DOE/CH-10(3)

**IDENTIFICATION OF SITES  
WITHIN THE PALO DURO BASIN:  
VOLUME 3—RESPONSES TO COMMENTS**

**U.S. DEPARTMENT OF ENERGY  
OFFICE OF CIVILIAN RADIOACTIVE WASTE MANAGEMENT  
SALT REPOSITORY PROJECT OFFICE**

Figure 3-1. Data Base for Dockum Group Studies

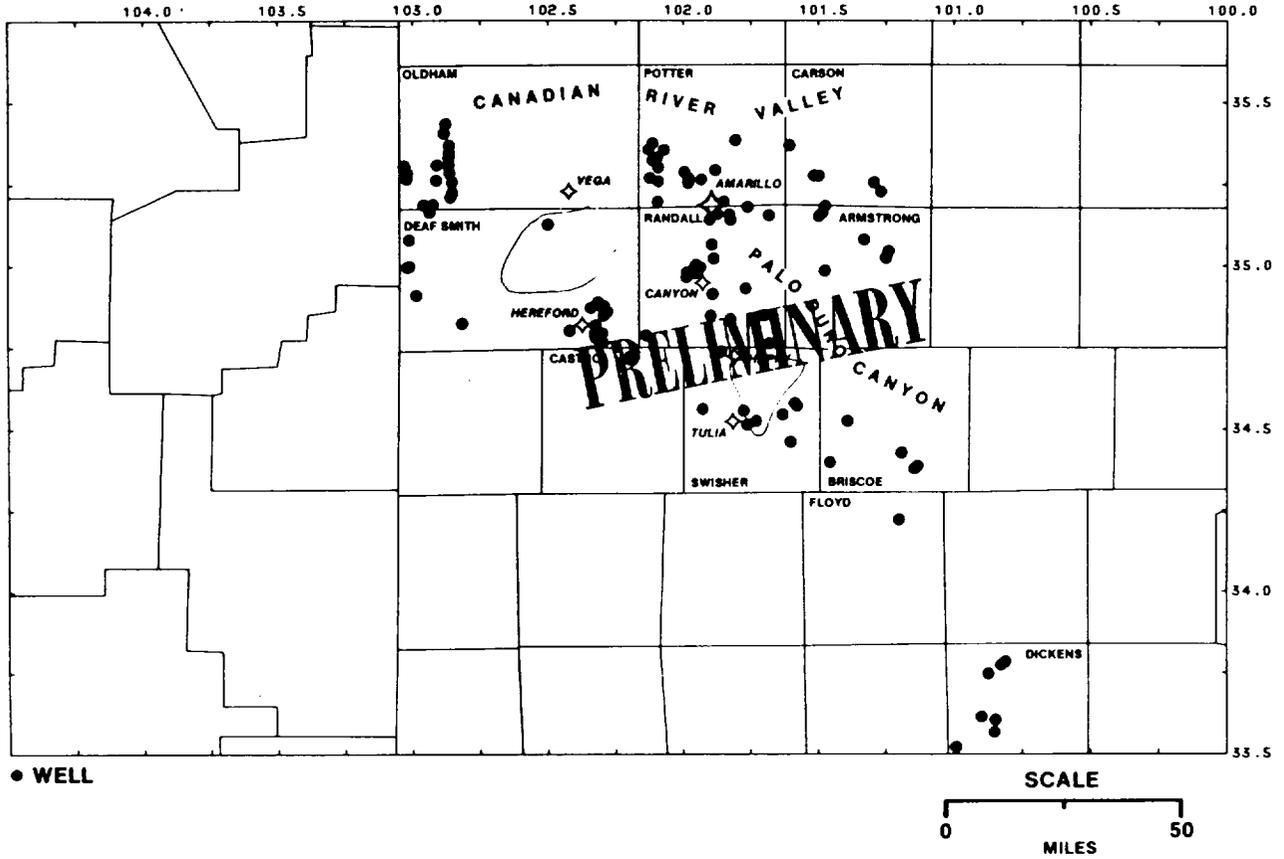
Questions and comments concerning the Santa Rosa or Dockum Group were generally of one of the following types:

- "The Santa Rosa was not even mentioned in the text."
- "DOE should mention that the Santa Rosa contains fresh water (at levels dipping to the southeast) and is a significant resource. The Santa Rosa should have been a descriptor in the site identification process."
- "The Dockum Group is not hydrologically connected (to the Ogallala) throughout all of Swisher County; therefore, it should be discussed separately."
- "What about the prolific well the Richardsons or others have in the Santa Rosa?"

The draft report did repeatedly refer to a Dockum aquifer (the Santa Rosa) or potential water-bearing units in the Dockum Group. (These references occurred on pages 43, 62, 83, 89, and Figure 3-7 of the Deaf Smith report and pages 39, 60, 80, 83 and Figure 3-7 of the Swisher report.) The discussion of previous exploration/exploitation of resources (Section 3.6.1 of the report) notes that "water-bearing units of the Dockum Group have also been locally developed". The terms "Santa Rosa" or "Santa Rosa sandstone", being locally familiar terms, have been used parenthetically in the revised report whenever the Dockum aquifers are discussed.

The description of the Dockum Group (Santa Rosa) aquifer has been improved in the final report (page 29, Volume 1, and page 30, Volume 2). Reference is made to a High Plains Underground Water Conservation District No. 1 report. DOE has acknowledged that water-bearing units in the Dockum Group are potentially important resources. Their use is not in conflict with safe isolation of radioactive waste because wells into the Dockum would not reach the salt units that provide a barrier to radionuclide release. If the Santa Rosa had been used as a descriptor, the result would have been the same because the sparse data base available does not permit showing variation across the locations; this means the descriptor would not have been selected as a discriminator. Figure 3-1 shows that few wells exist in the locations that are completed only in the Dockum. Had enough data been available, it might have been possible to use the saturated thickness of the Santa Rosa as a discriminator in the site identification process. Section 3.9.2.5 of the
